Access Compliance Report

Public Rights-of-Way

(Curb Ramps)

Intersection ID: 15498	Main Street: ORDERMORE_AV	Cross Street: PARK_RD	Location: SE
ADA ID: 52A768539E38	Ramp Type: Directional1	Initial Pass/Fail: Fail	Overall Compliance: No
Severity Score: 1.25			
Codes/Mitigation Info/Possible Solution		Field Measurements/Component Compliance

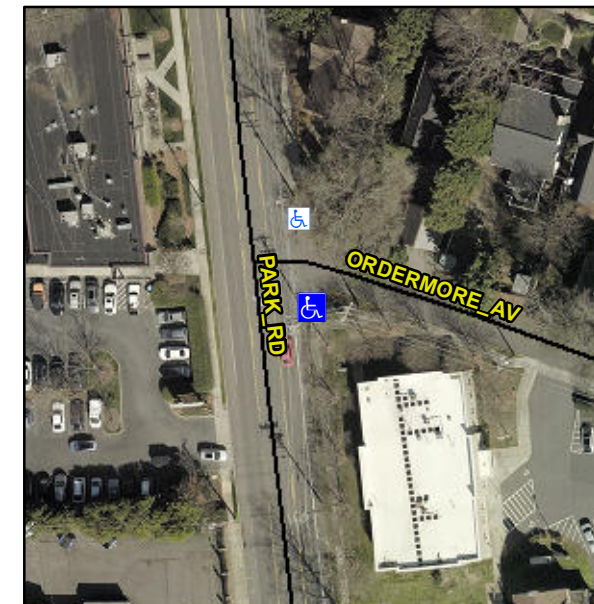
Surveyor Notes:

ASP LIP 1.0"

PROW/ADA:

R304.5.3

Possible Solutions:

Remove & Replace Entire Ramp.
